UNITED STATES PATENT AND TRADEMARK OFFICE

APPLICATION NO.	FILING DATE	FIRST NAMED INVENTOR	ATTORNEY DOCKET NO.	CONFIRMATION NO.
10/092,767	03/07/2002	Dieter Kress	2146.GLE.PT	8734

Office Action Summary

DETAILED ACTION

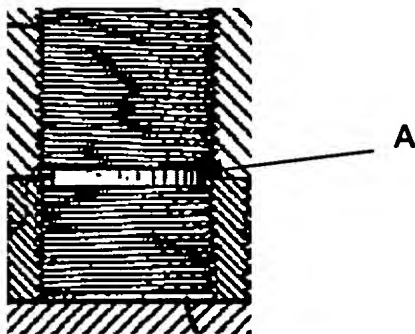
As to claim 6, Sanderson discloses a device for connecting two tool parts **1,2,4** configured for receiving a threaded spindle, each of the tool parts having an associated threaded area, and wherein the device comprises:

a threaded spindle **3** having a projecting shoulder **7**, the outside diameter of which is slightly smaller than the interior diameter of the associated threaded area of one of the tool parts **1** to approximate the interior diameter such that the projecting shoulder serves to guide the threaded spindle into, and provide axial and angular alignment between, the two tool parts, the projecting shoulder having a centered (co-

centrically centered with the axis of spindle 3) and axially inwardly extending opening 10 configured to receive a tool for effecting rotation of the threaded spindle when the projecting shoulder is inserted within a tool part (Figures 1 and 7).

As to claim 7, Sanderson discloses a device wherein a threaded spindle 3 has a first end 7 and a second end A and further comprises a projecting shoulder 7,A at each said end (Figure 1 reprinted with annotations below).

As to claim 8, Sanderson discloses a device wherein the outside diameter of a projecting shoulder 7,A at each end 7,A is slightly smaller than the interior threads of an associated threaded area of a corresponding tool part 1,2,4 to approximate the interior threads thereof to guide a threaded spindle 3 into, and provide axial and angular alignment between, the two tool parts (Figure 1).

As to claim 9, Sanderson discloses a device wherein a threaded spindle 3 has two threaded sections 5,6, each being threaded in a direction opposite the other and assigned to corresponding threaded areas of tool parts 1,2,4 (Figure 1).

a threaded spindle **3** having a first threaded sections **5** for engaging the threaded area of the first tool piece and a second threaded section **6** for engaging the threaded area of the second tool piece, and wherein the threaded spindle has a shoulder **7** extending beyond one of the threaded sections, the projecting shoulder having an outer diameter slightly smaller than the interior diameter of the threaded area of the first tool piece for approximating the interior diameter of the threaded area to thereby guide the threaded section into the threaded area and provide axial and angular alignment of the first and second tool pieces, the projecting shoulder having a centered (co-centrally centered with the axis of spindle **3**) and axially inwardly extending opening **10** configured for receiving a tool for effecting rotation of the threaded spindle via the projecting shoulder when inserted in the first or second tool piece (Figures 1 and 7).

As to claim 14, Sanderson discloses a connection wherein a threaded spindle **3** has a opposing ends **7,A** and has a projecting shoulder **7,A** at each end (Figure 1).

Examiner disagrees. As to claims 6 and 12, Sanderson discloses a device comprising a threaded spindle **3** having a projecting shoulder **7** having a centered (co-centrally centered with the axis of spindle **3**) and axially inwardly extending opening **10** configured to receive a tool for effecting rotation of the threaded spindle when the projecting shoulder is inserted within a tool part (Figure 1).
